**APPLICATION FOR PERMISSION UNDER SECTION 16 TOWN PLANNING
APPLICATION FOR THE PROPOSED TEMPORARY WAREHOUSE (EXCLUDING
DANGEROUS GOODS GODOWN) AND ASSOCIATED FILLING OF LAND FOR A
PERIOD OF 3 YEARS IN "AGRICULTURE" ZONE IN LOT NOS. 956 AND 959 RP IN
D.D. 107, FUNG KAT HEUNG ROAD, KAM TIN, YUEN LONG, NEW TERRITORIES**

Town Planning Application No. A/YL-KTN/1283

Submission of Further Information (1)

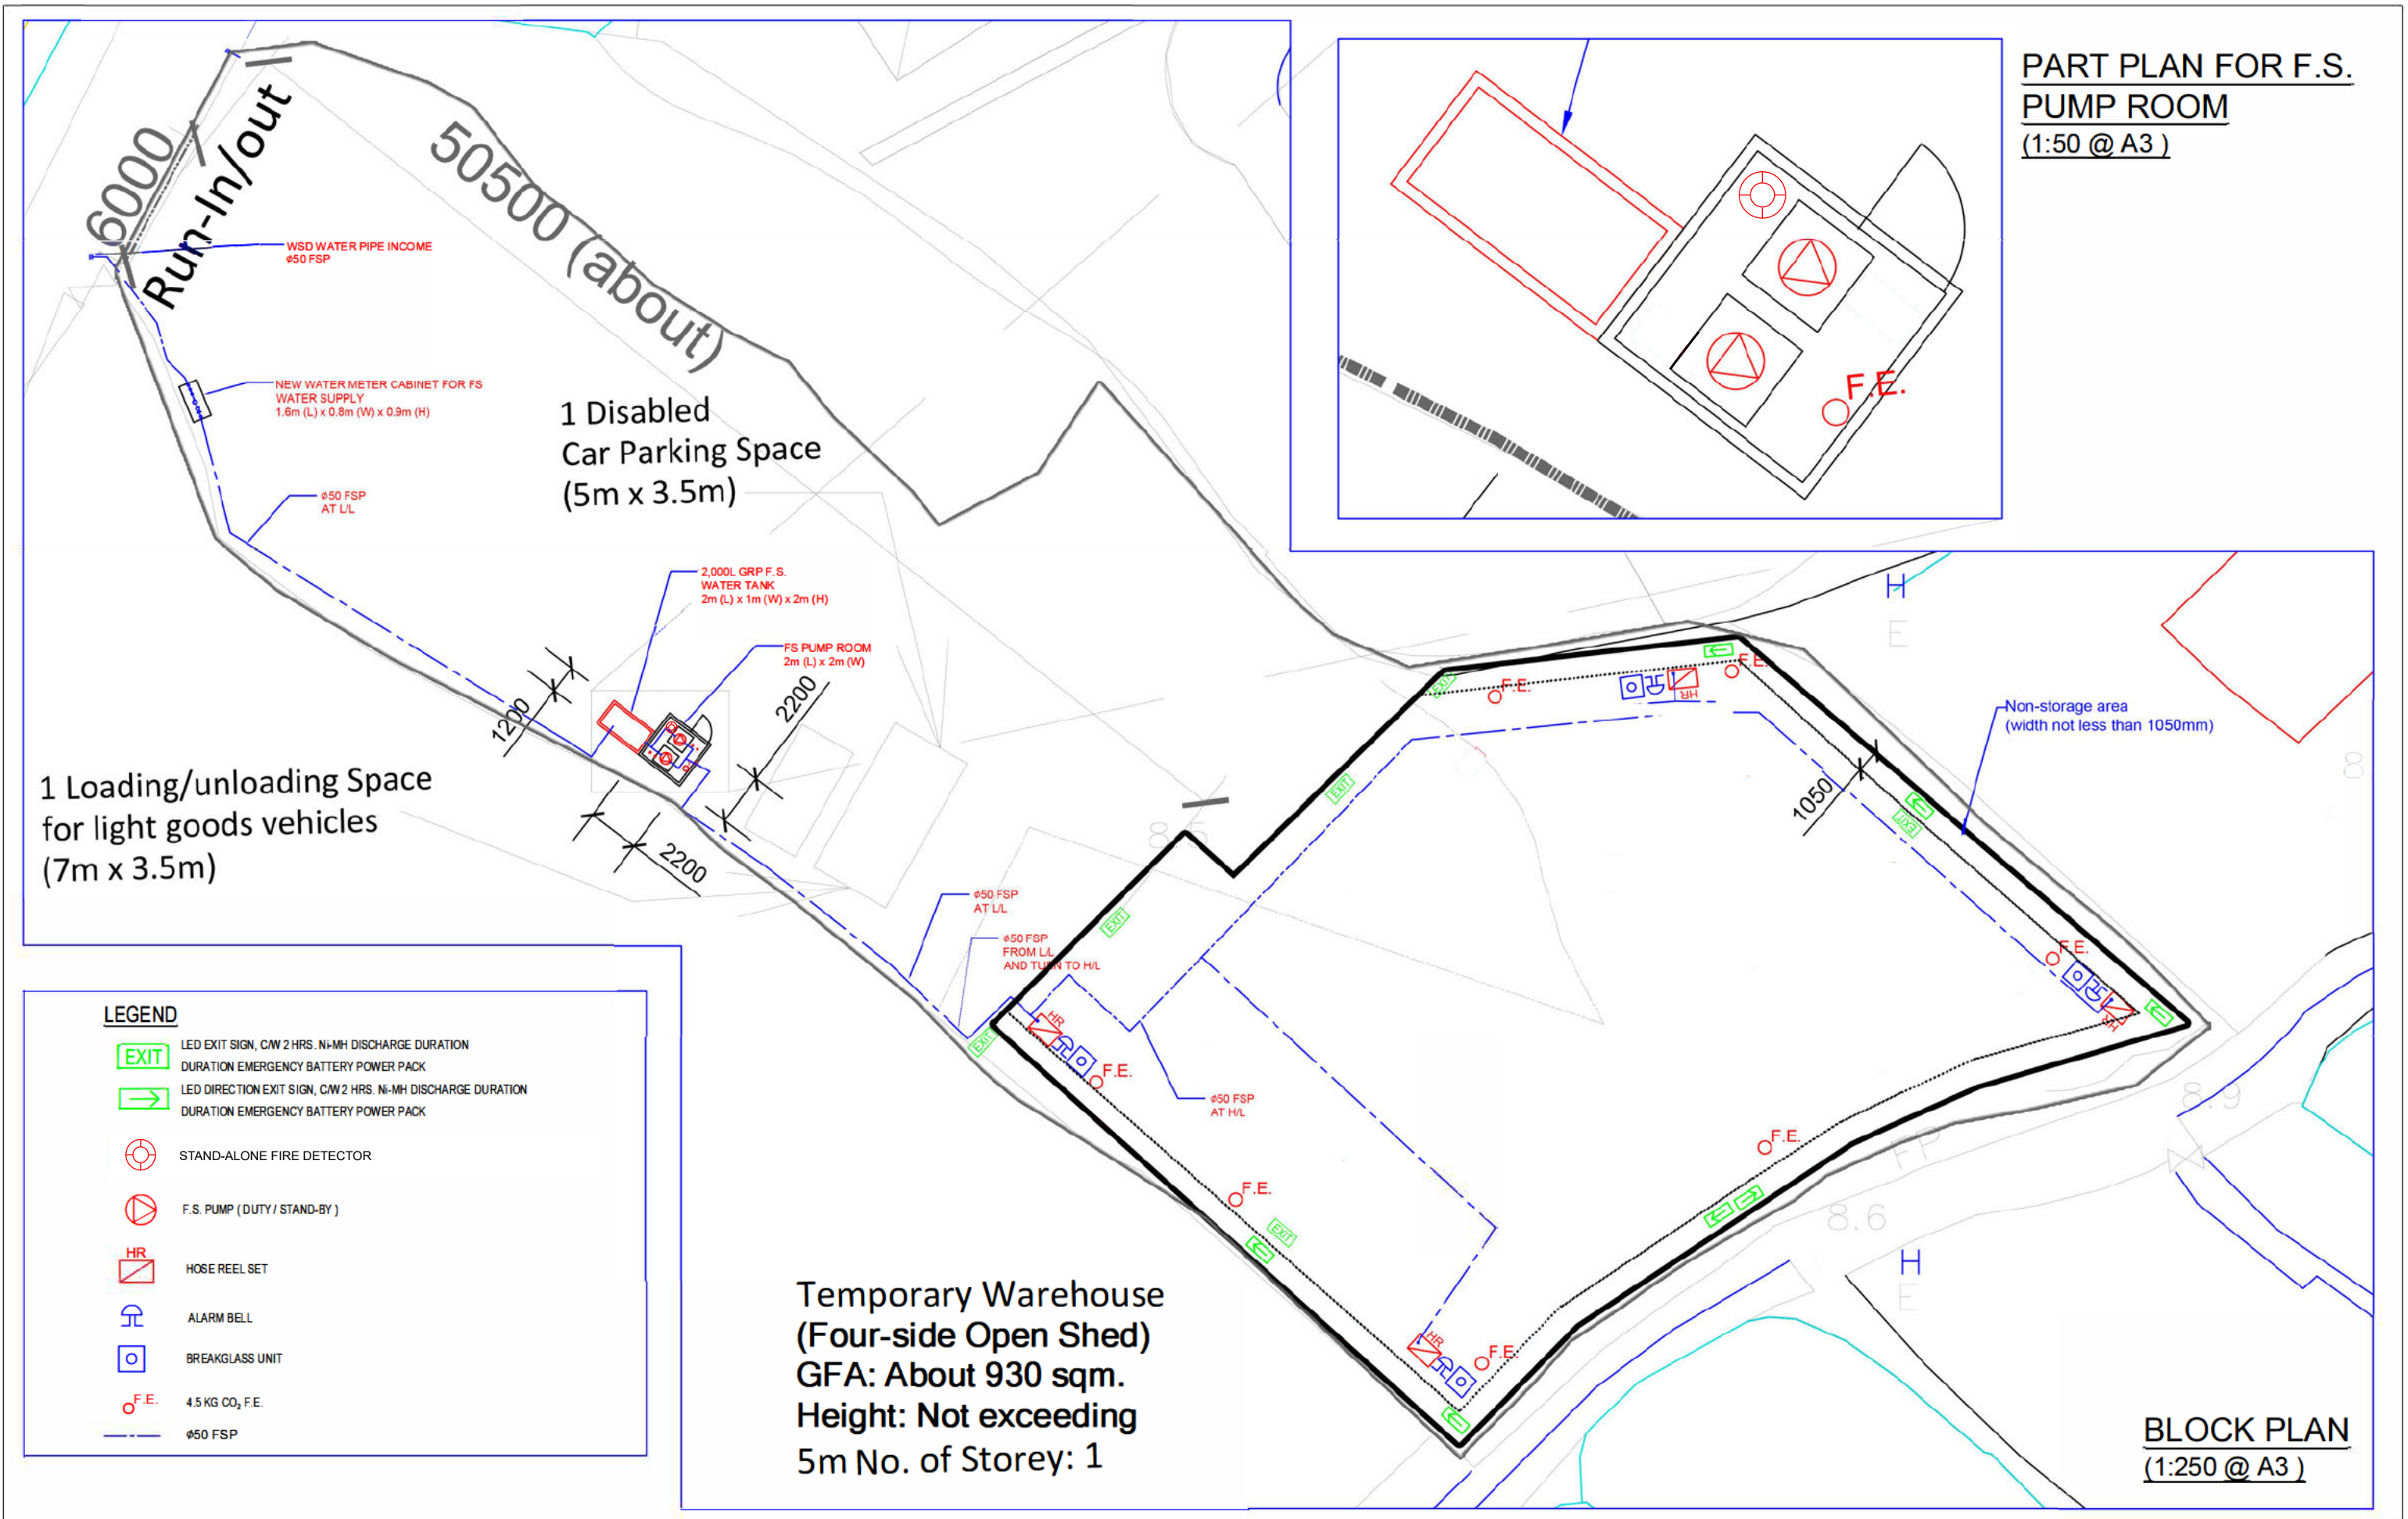
Departmental Comments (Email from Planning Department dated 22.09.2026)	
Departmental Comments	Response
<u>FSD</u>	
i. For enclosed structure with gross floor area not exceeding 230 m ² , i.e. FS Pump Room, portable fire extinguisher and stand-alone fire detector shall be provided;	Revised. Please refer to Appendix 1 – Revised FSI Proposal .
ii. In relation to item (i) above, if two or more stand-alone fire detectors are installed in an enclosed structure, all detectors shall be interconnected (either wired or wirelessly) such that when one of the detectors is triggered, all connected detectors shall sound an alarm simultaneously;	Noted.
iii. Stand-alone fire detectors shall be provided in accordance with the “Stand-alone Fire Detector General Guidelines on Purchase, Installation & Maintenance [Sep 2021]”;	Noted. Please refer to Appendix 1 – Revised FSI Proposal .
iv. Modified hose reel system, fire alarm system, emergency lighting and directional & exit signs are considered as self-upgrades and are not mandatory requirements of FSD;	Noted.

v. If the applicant self-initiates the provision of a modified hose reel system, the standard and specification shall be provided in accordance with the “Codes of Practice for Minimum Fire Service Installations and Equipment and Inspection, Testing and Maintenance of Installations and Equipment [September 2022 revision]”; and	Noted. The standard and specification of the modified hose reel system is in accordance with the “Codes of Practice for Minimum Fire Service Installations and Equipment and Inspection, Testing and Maintenance of Installations and Equipment [September 2022 revision]”. Please refer to Appendix 1 – Revised FSI Proposal .
vi. For shed(s) open on 2 sides or more, only fire extinguishers shall be provided.	Noted.
